PLANNING COMMISSION MEETING TUESDAY, JULY 12, 2022 6:00 P.M. Council Chambers 40 W MAIN ST, NEWARK, OH 43055

5. SITE PLAN REVIEW FOR 1000 BRICE ST. - NEW COMMERCIAL BLDG. FOR PRIVATE GYM-RECREATION

JULY 12, 2022 PLANNING COMMISSION MEETING

1. PC FILE 2022-24: SITE PLAN FOR NEW COMMERCIAL BUILDING FOR PRIVATE GYM-RECREATION, 1000 BRICE STREET

1. PC FILE 2022-27: SITE PLAN FOR BUILDING ADDITION AND SMOKER ENCLOSURE AT CITY BARBEQUE, 1195 WEST CHURCH STREET

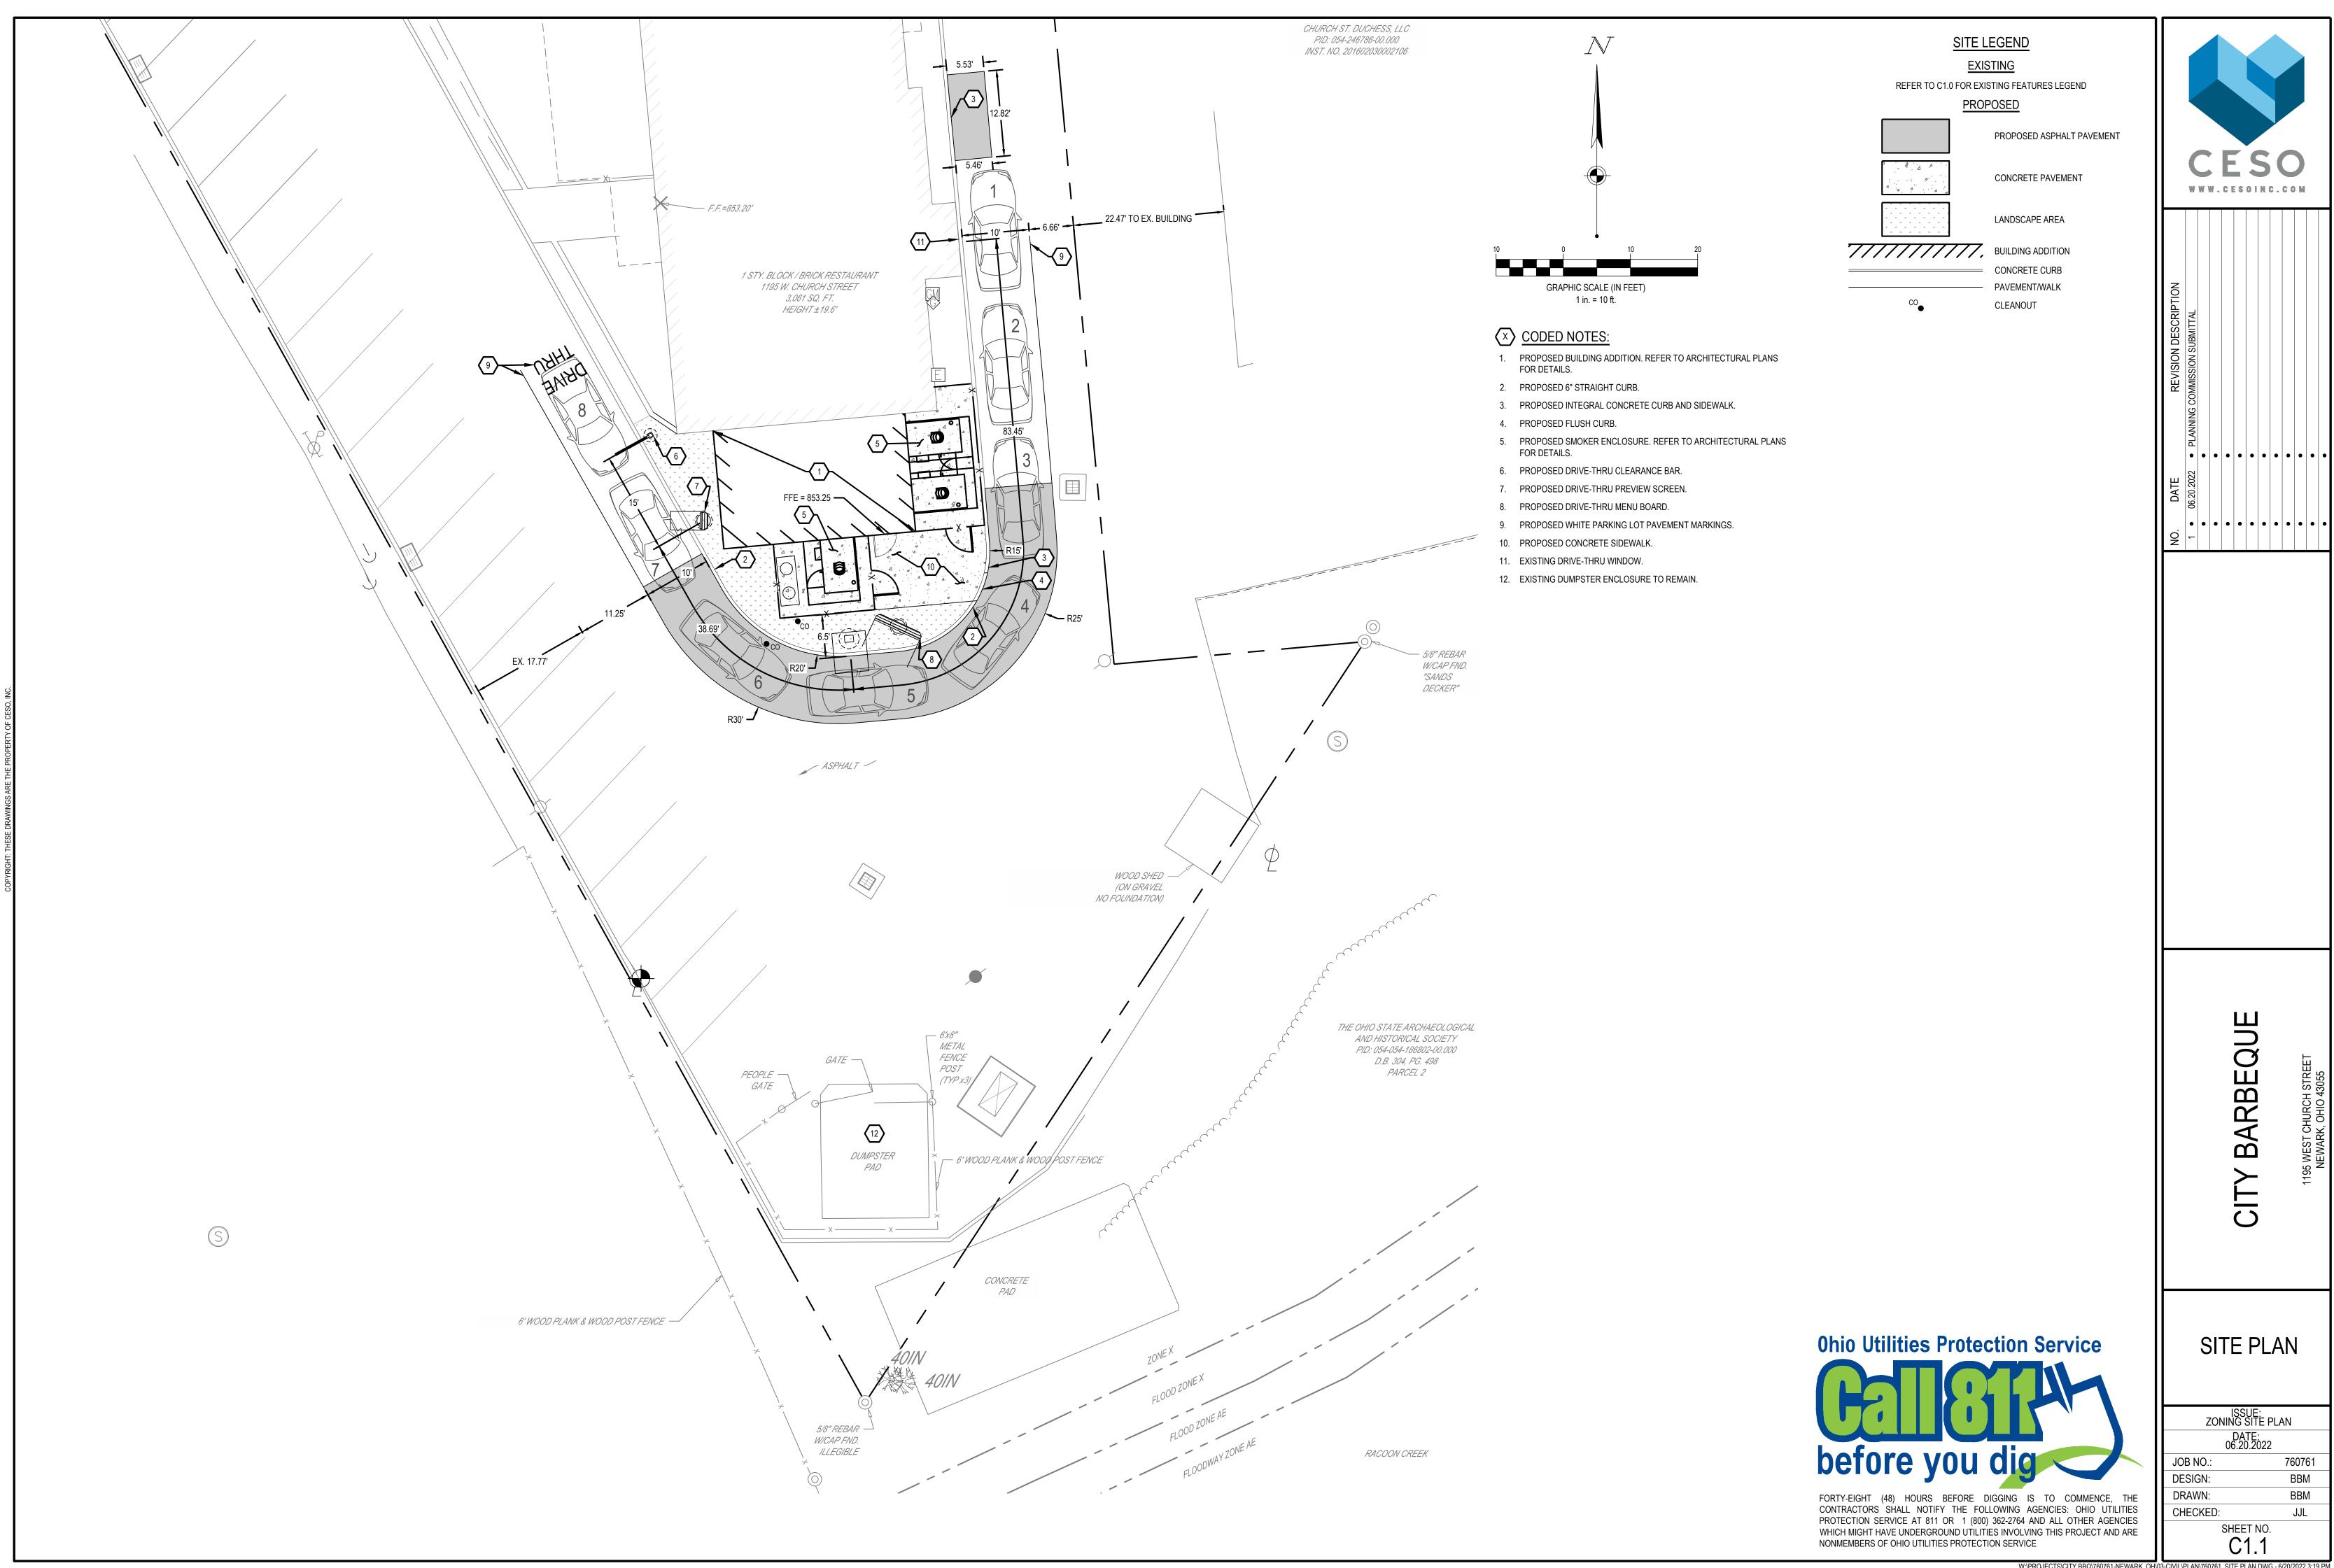
This proposal meets all of the technical requirements. On that basis, staff recommends approval of the Site Plan for this structure.
